ADDENDUM 4

BID TITLE: File No. 55-24 Green Road Pump Station

GREEN ROAD PUMP STATION– FILE NO. 55-24

ADDENDUM NO. 3

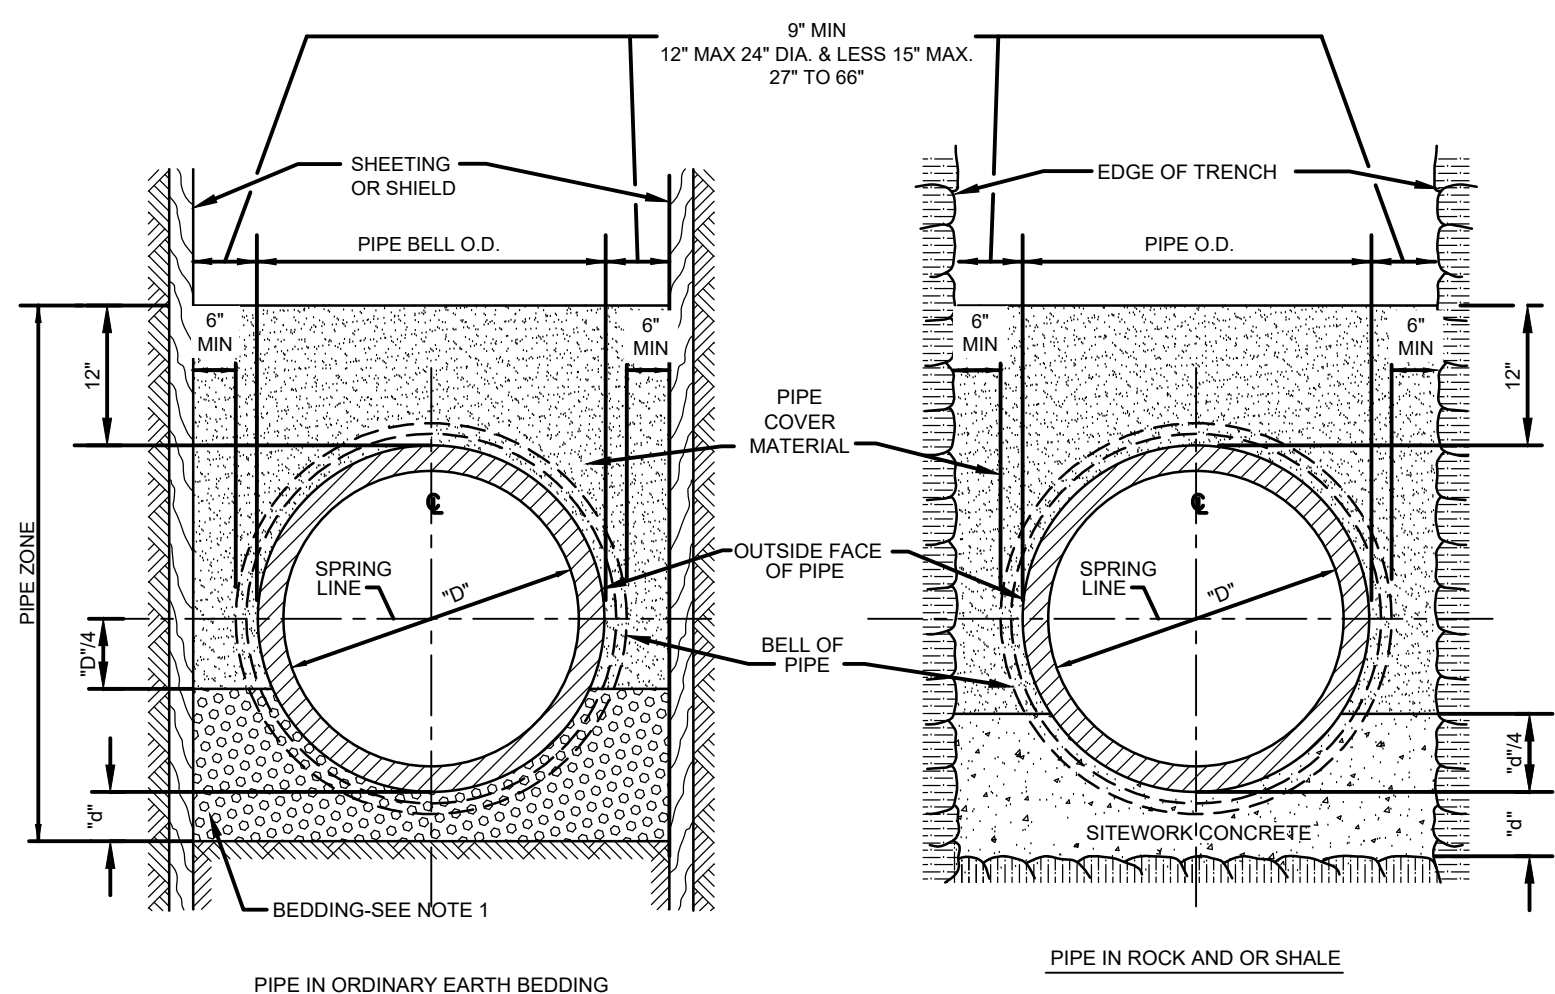
1. G-02: updated drawing index to indicate changes to numbers and titles of I sheets
2. C-03: updated to include concrete repair detail
3. E-06: updated to show the addition of the Local Control Stations (RIOs), the Main Control Panel (PLC), and relocated RTU
4. E-11: updated to show revised LP2 Panel Schedule for addition of four LCPs and updated Main Control Panel
5. E-12: updated to show revised conduit riser for addition of four LCPs and updated Main Control Panel
6. I-04 thru I-08: updated to indicate relocation of RTU panel and installation of new PLC panel
7. I-09 and I-10: new sheets with new pump Local Control Panel detail
8. I-10A and I-10B: new sheets with new Main Control Panel details
9. I-12, I-14 thru I-22: new/updated sheets to provide networking and loop drawings for new PLC panel and pump Local Control Panels

CONCRETE PAVEMENT
NOT TO SCALE

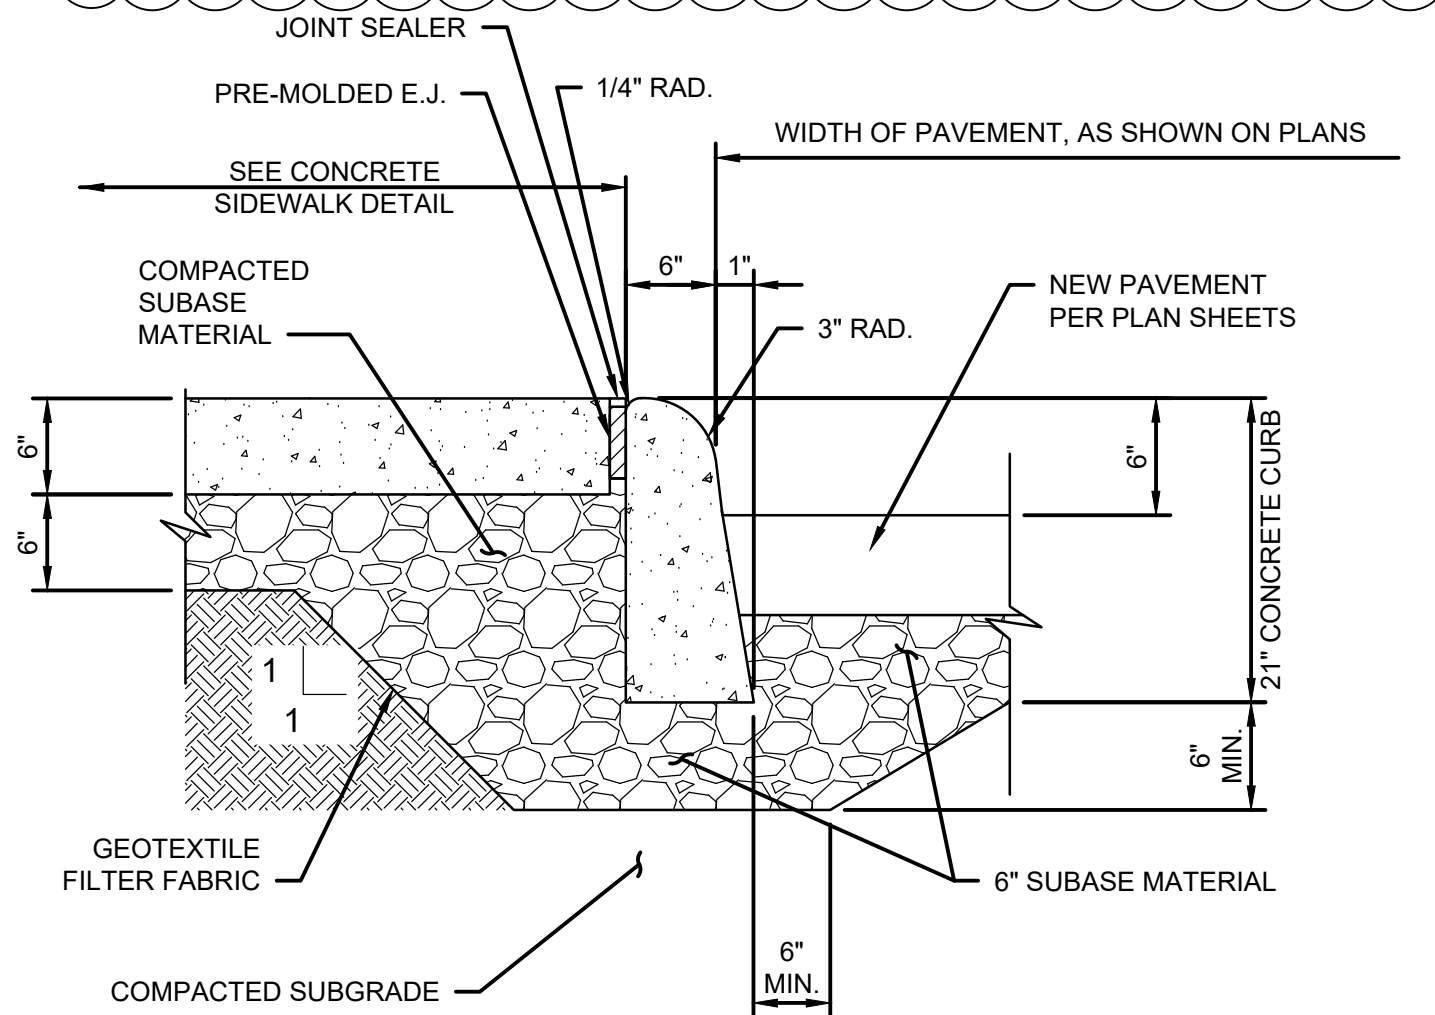
6. Please provide details for concrete pavement replacement and details for repairs to occur on the site. Details for the apron replacement at Green road, repair of concrete around manhole, Remove and replace sunken concrete slab (two locations), repair raise concrete slab to be flush with the adjacent drive shown on C-02.

8. The third legend item " Remove and replace existing concrete driveway as needed to perform excavation for pipe replacement and as noted in contract documents. All areas not impacted by excavation shall be repaired as per the contract documents". Please provide detail for the concrete in areas to be replaced. The second half of the legend note would lead us to believe that if it is not an area being removed and there is not a note specifically pointed to an area we are not to repair the areas. One example is that there are a number concrete joints that are deteriorated and filled with stone. There is not a detail provided for repairs, they are not called out, and the area will not be impacted by pipe replacement, therefore we would not need to perform any repairs?

Answer: Concrete Pavement Detail added to sheet C-03.

Answer: Concrete Pavement Detail added to sheet C-03. Refer to Section 01 02 50 for concrete repair requirements.

DRAWN BY: SJT	SCALE: NTS	CWD NO:	SHEET NO:
DESIGNED BY: SJT	DATE: 12/2021		I-04
CHECKED BY: VM

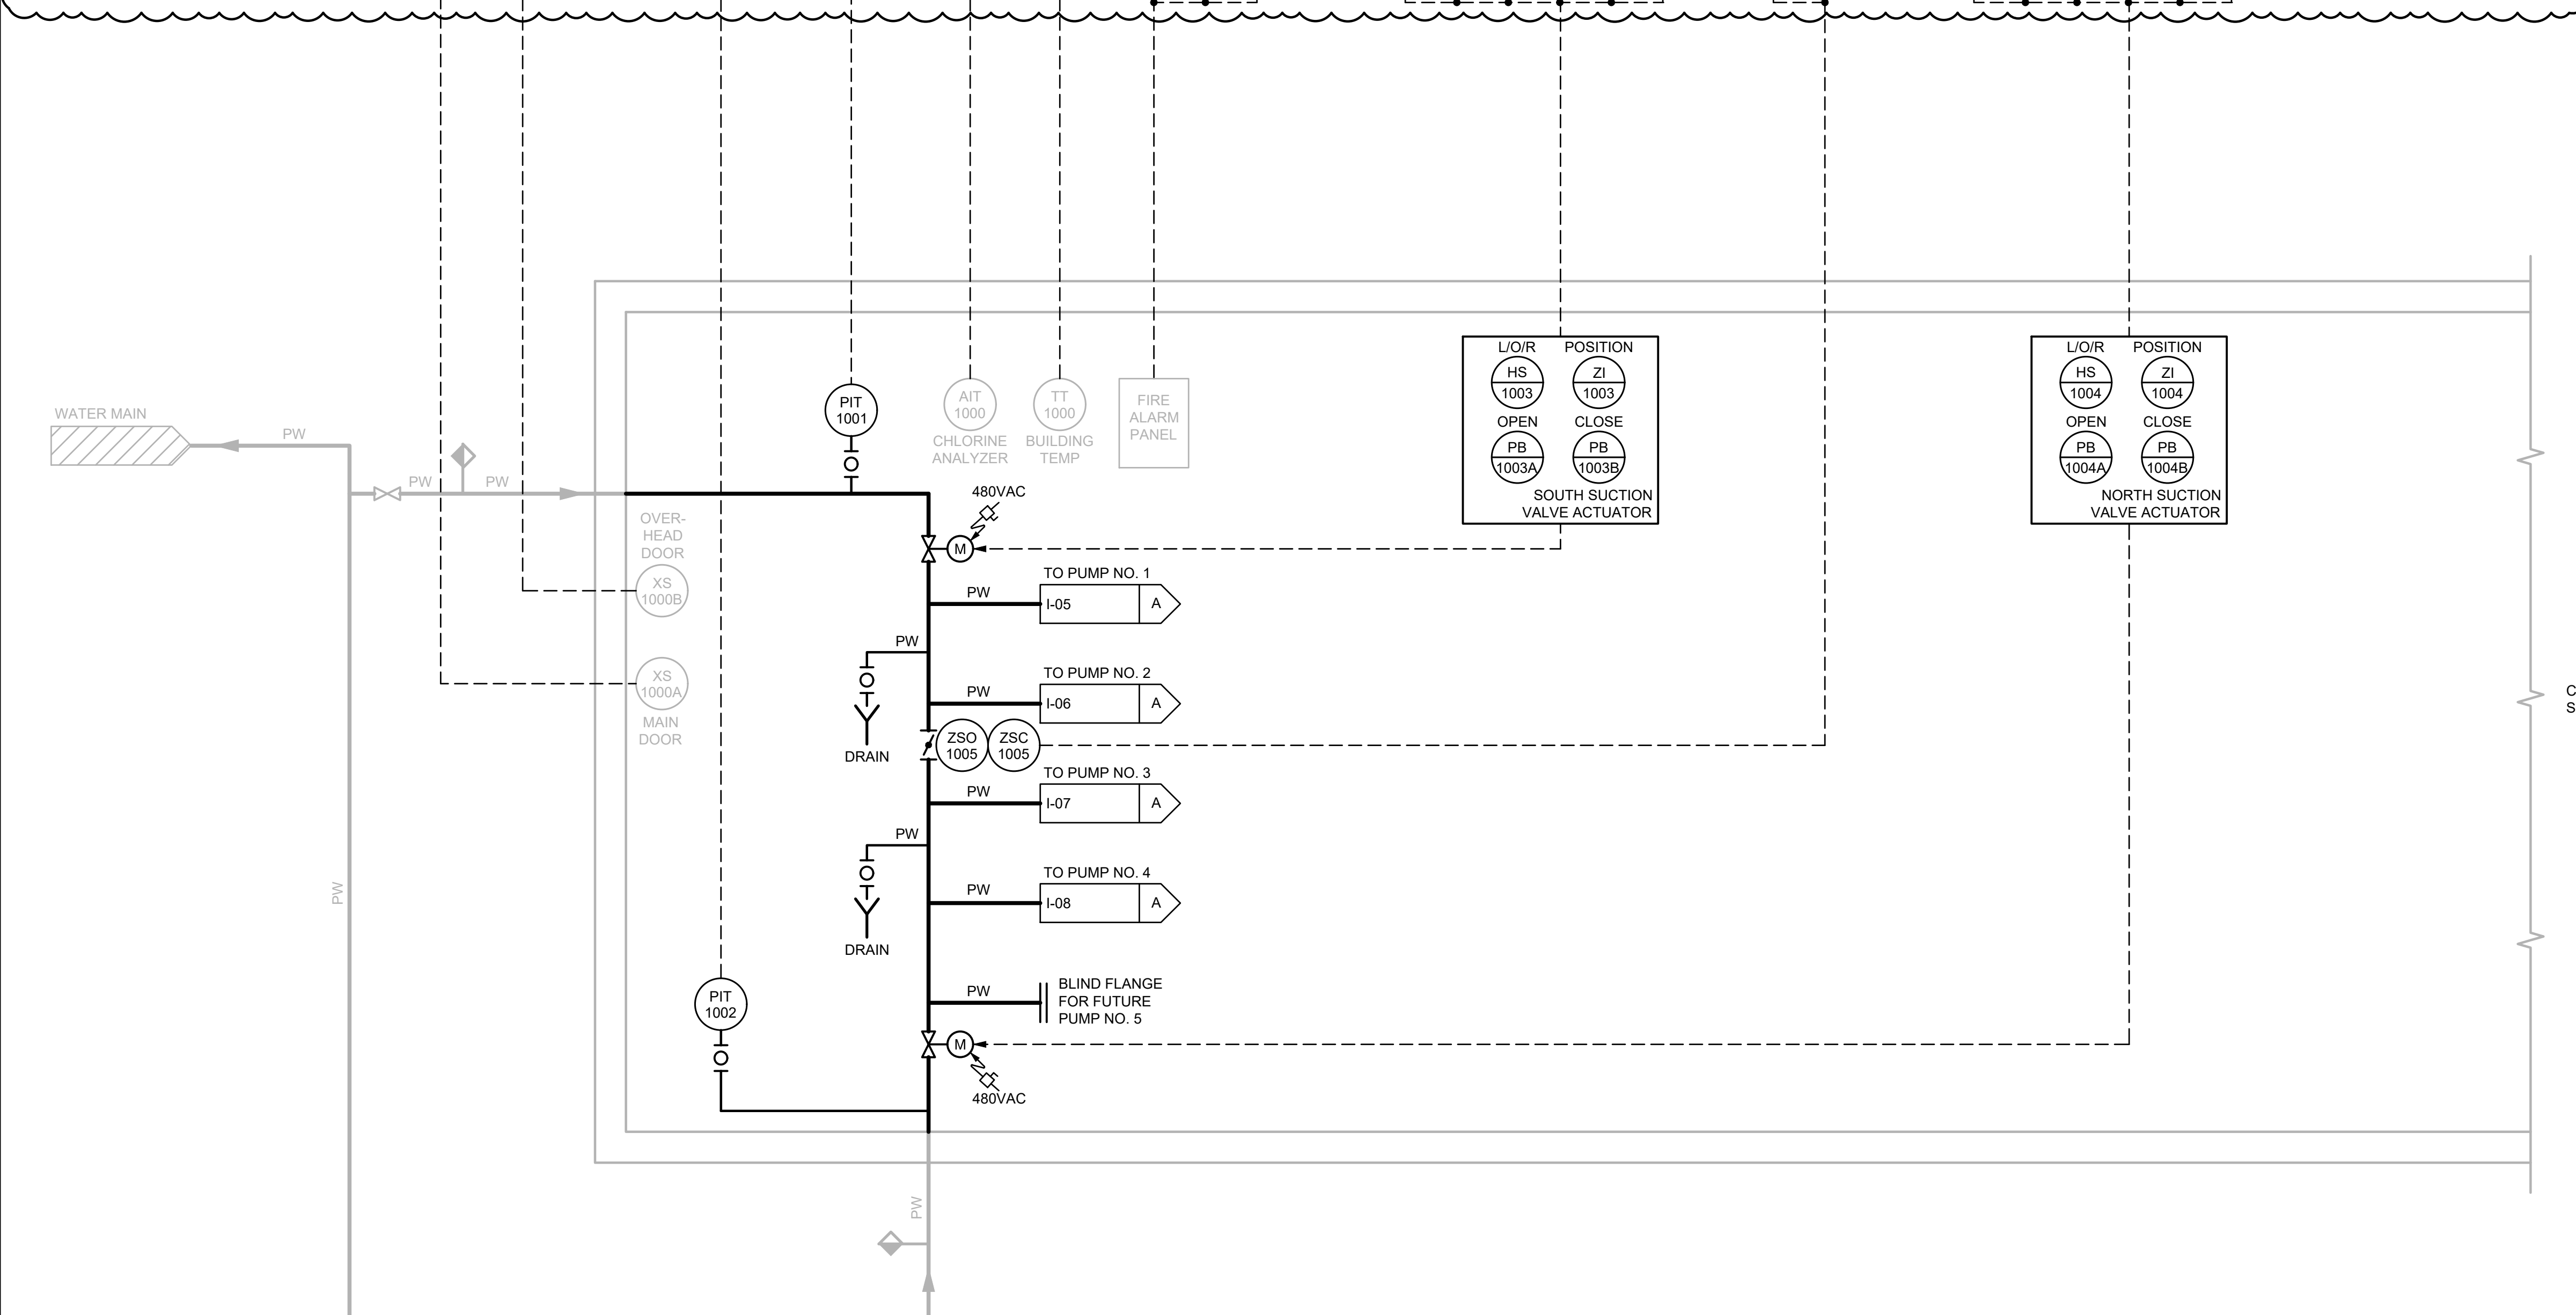
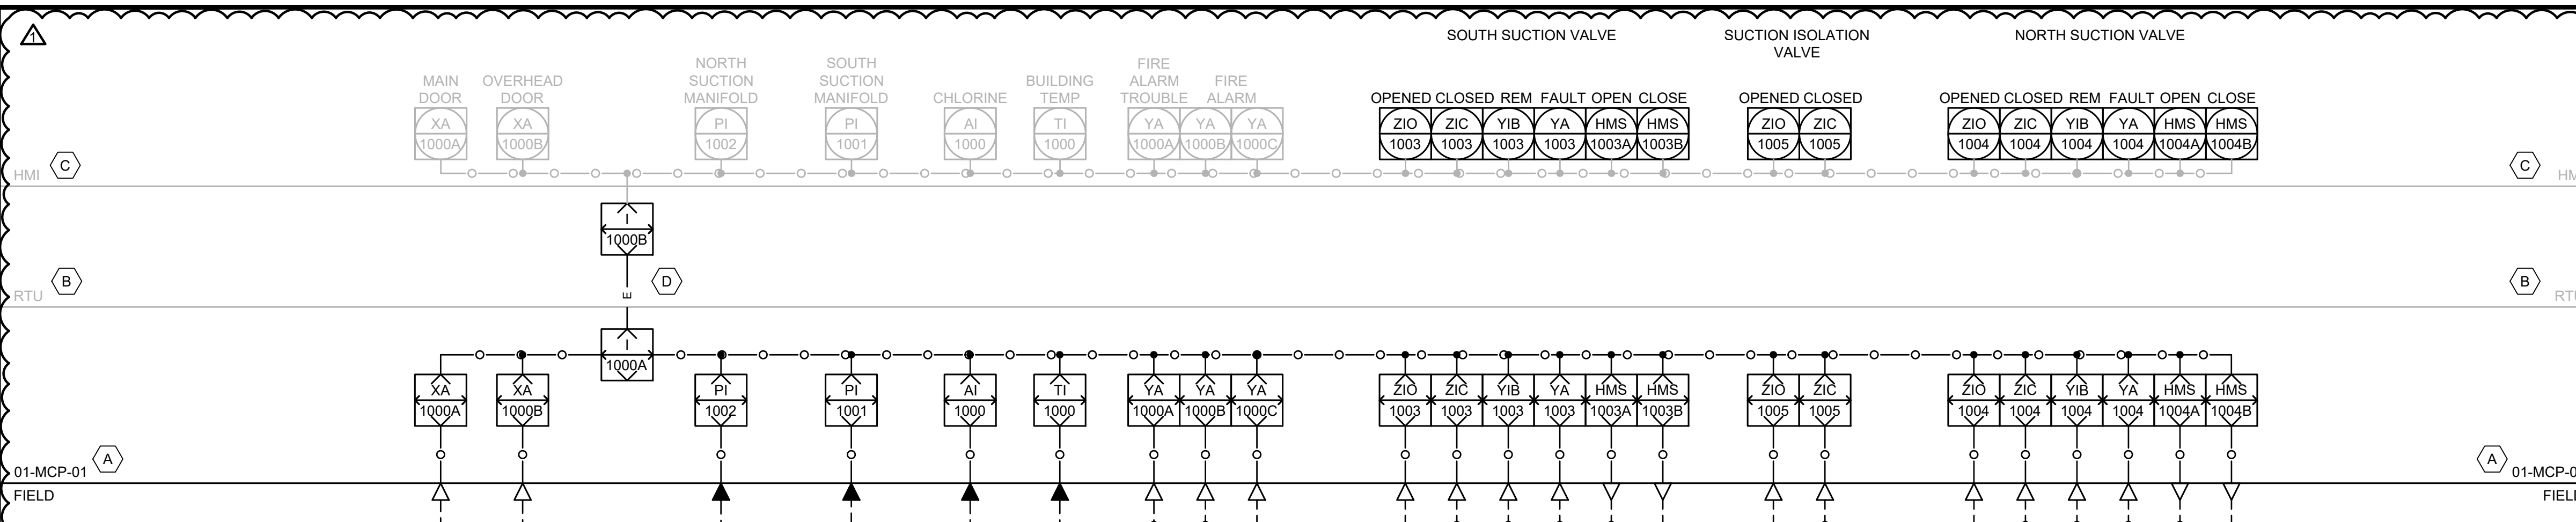
16. Drawing I-04 shows a number of existing points that do not appear to be indicated on the RTU Loop Drawings. An example is the Chlorine TI-1000 point. Are these points to be landed in the "Marshalling Cabinet"? Is it to be assumed that all points new and existing shown on drawings I-04, I-04A, I-05, I-06, I-07, and I-08 are to be landed in the "Marshalling Cabinet" prior to being pulled to the RTU?

Answer: This is indicated in the updated I drawings above. Marshaling Panel drawings have been removed and PLC Panel drawings have been added.
